Access Compliance Report

Public Rights-of-Way

(Curb Ramps)

Intersection ID: 49796	Main Street: TRISTAN_CT	Cross Street: ATKINS_RIDGE_DR	Location: E
ADA ID: 8FBD6A04B4AB	Ramp Type: PerpDiag	Initial Pass/Fail: Fail	Overall Compliance: No
Severity Score: 0			
Codes/Mitigation Info/Possible Solution		Field Measurements/Component Compliance

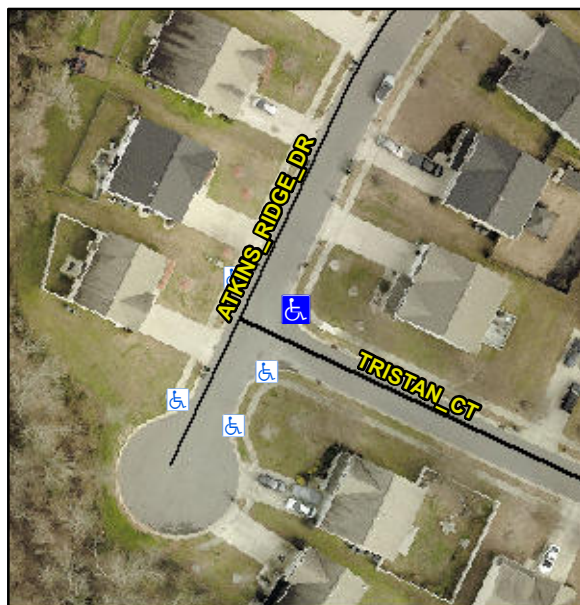
Compliance	Description	Data	Compliance	Description	Data
N/A	Ramp Length (in)	47.0	Yes	Ramp Slope (%)	5.3
Yes	Ramp Width (in)	48.1	Yes	Ramp XSlope (%)	1.3
N/A	Flare Type LT	N/A	N/A	Flare Type RT	N/A
N/A	Flare Slope LT (%)	N/A	N/A	Flare Slope RT (%)	N/A
N/A	Flare Traversable LT?	N/A	N/A	Flare Traversable RT?	N/A
N/A	Landing Length (in)	N/A	N/A	DWS Provided?	N/A
N/A	Landing Width (in)	N/A	N/A	DWS Contrast?	N/A
N/A	Landing Slope (%)	N/A	N/A	DWS Length (in)	N/A
N/A	Landing X Slope (%)	N/A	N/A	DWS Full Width?	N/A
N/A	Landing Curb? (Y/N)	N/A	N/A	DWS Offset (in)	N/A
N/A	Shared Landing?	N/A			
N/A	Gutter Ponding?	N/A	N/A	Gutter Slope (%)	N/A
N/A	Gutter Lip Ht (in)	N/A	N/A	Gutter X Slope (%)	N/A
N/A	Painted X Walk1?	No	N/A	Painted X Walk2?	No
	X Walk 1 Direction	To NW		X Walk 2 Direction	To SW
N/A	X Walk 1 Width (in)	N/A	N/A	X Walk 2 Width (in)	N/A
	X Walk 1 Slope (%)	0.9		X Walk 2 Slope (%)	2.1
	X Walk 1 X Slope (%)	1.3		X Walk 2 X Slope (%)	0.5

N/A	Ramp inside XWalk1?	N/A	N/A	Ramp inside XWalk2?	N/A
	Road Slope (%)	2.2	N/A	Clear Space?	N/A
	Road X Slope (%)	3.2	N/A	Clear Space to XWalk (in)	N/A
N/A	Any Obstructions?	N/A	N/A	Storm Grate/Utility Hazard?	N/A
	Obstruction Type			Storm Grate/Utility Type	
		N/A			N/A
		Yes		Surface Condition? (G/P)	Good

Remove & Replace Curb Ramp With Two New Directional Ramps or Equivalent.
